PLANNING AND ZONING CASE CHECKLIST

P&Z CASE # Z2022-028 P&Z DATE June 14, 2022 CC DATE June 20, 2022 Approved/Denied

CONCEPT PLAN
SOUTHSIDE HILLS
264.5 Acres
Rockwall, Texas

Z2022-028 Zoning Change (AG to PD) for the Southside Hills Subdivision

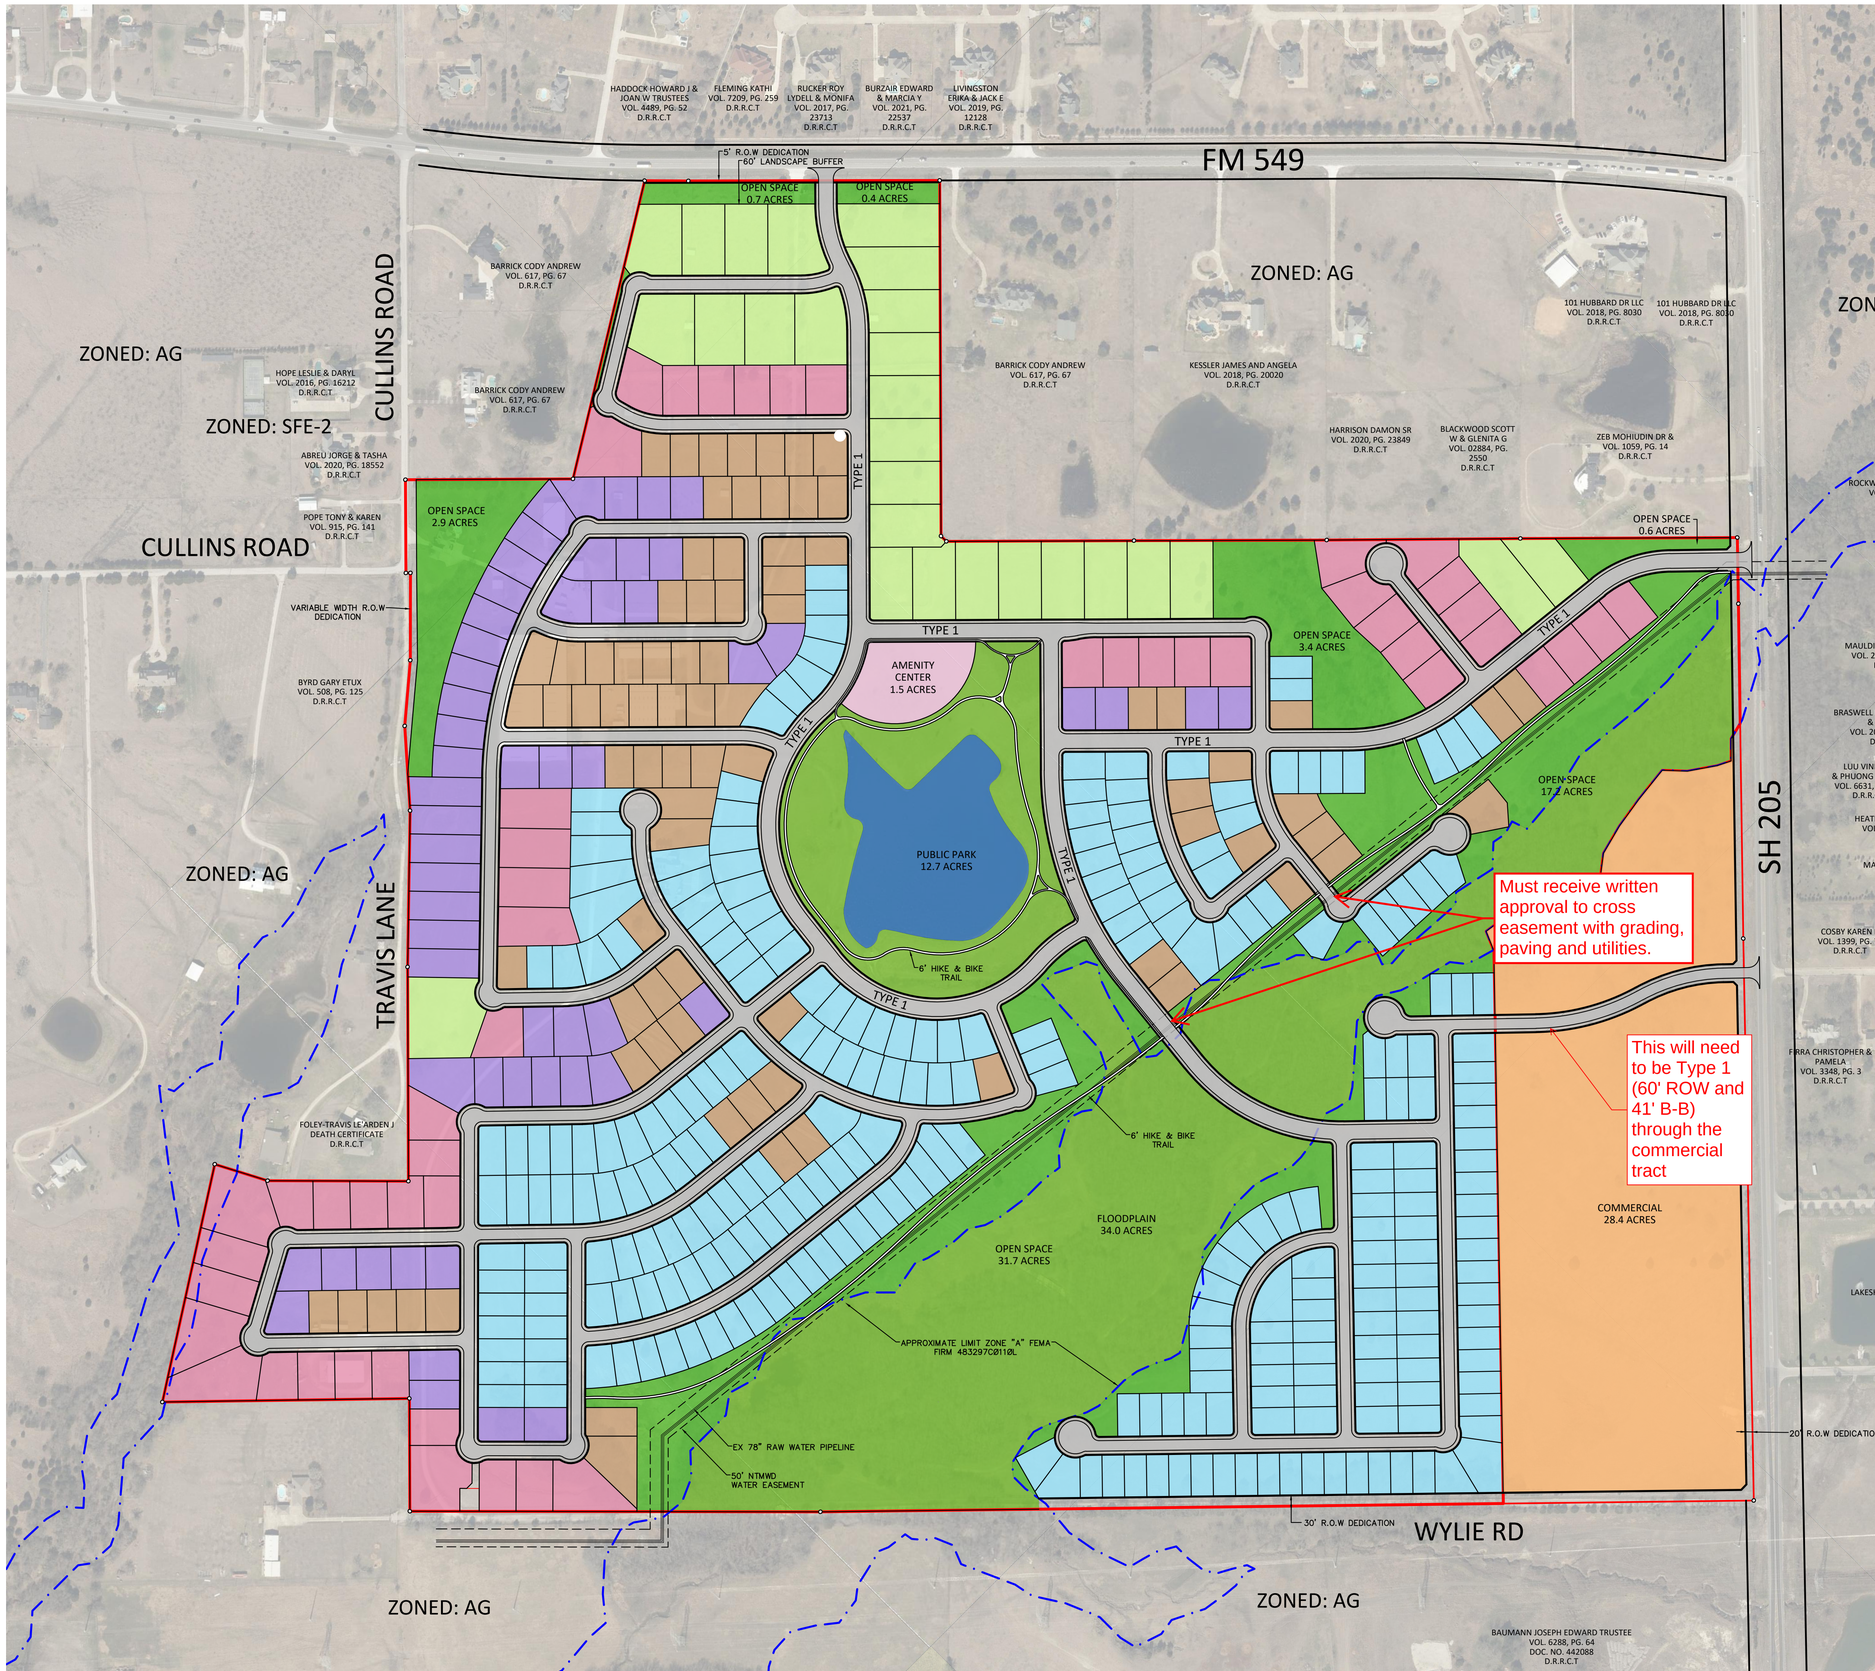
General Items:
- Must meet City Standards of Design and Construction
- 4% Engineering Inspection Fees
- Impact Fees (Water, Wastewater & Roadway)
- Minimum easement width is 20' for new easements. No structures allowed in easements.
- Retaining walls 3' and over must be engineered.
- All retaining walls must be rock or stone face. No smooth concrete walls.
